PIC24FJ256GA110 Family Silicon Errata and Data Sheet Clarification

The PIC24FJ256GA110 family devices that you have received conform functionally to the current Device Data Sheet (DS39905E), except for the anomalies described in this document.

Data Sheet Clarifications

The following typographic corrections and clarifications are to be noted for the latest version of the device data sheet (DS39905E):

FIGURE 2-3 FREQUENCY vs. ESR PERFORMANCE FOR SUGGESTED VCAP

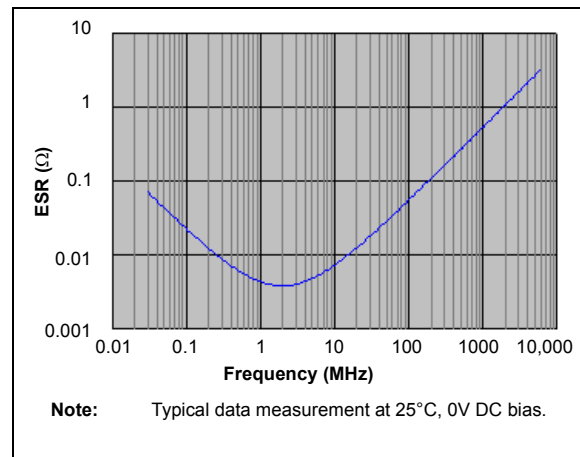
Section 2.4 Voltage Regulator Pins (ENVREG/DISVREG and VCAP/VDDCORE) has been replaced with a new and more detailed section. The entire text follows:

When the regulator is enabled, a low-ESR ($< 5\Omega$) capacitor is required on the VCAP/VDDCORE pin to stabilize the voltage regulator output voltage. The VCAP/VDDCORE pin must not be connected to VDD and must use a capacitor of 10 μF connected to ground. The type can be ceramic or tantalum. Suitable examples of capacitors are shown in [Table 2-1](#). Capacitors with equivalent specifications can be used.

Designers may use [Figure 2-3](#) to evaluate ESR equivalence of candidate devices.

FIGURE 2-4 DC BIAS VOLTAGE vs. CAPACITANCE CHARACTERISTICS

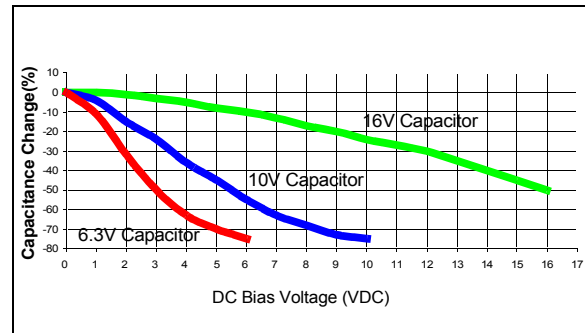
In addition to temperature tolerance, the effective capacitance of large value ceramic capacitors can vary substantially, based on the amount of DC voltage applied to the capacitor. This effect can be very significant, but is often overlooked or is not always documented.

A typical DC bias voltage vs. capacitance graph for 16V, 10V and 6.3V rated capacitors is shown in Figure 2-4.

When selecting a ceramic capacitor to be used with the internal voltage regulator, it is suggested to select a high-voltage rating, so that the operating voltage is a small percentage of the maximum rated capacitor voltage. For example, choose a ceramic capacitor rated at 16V for the 2.5V core voltage. Suggested capacitors are shown in Table 2-1.
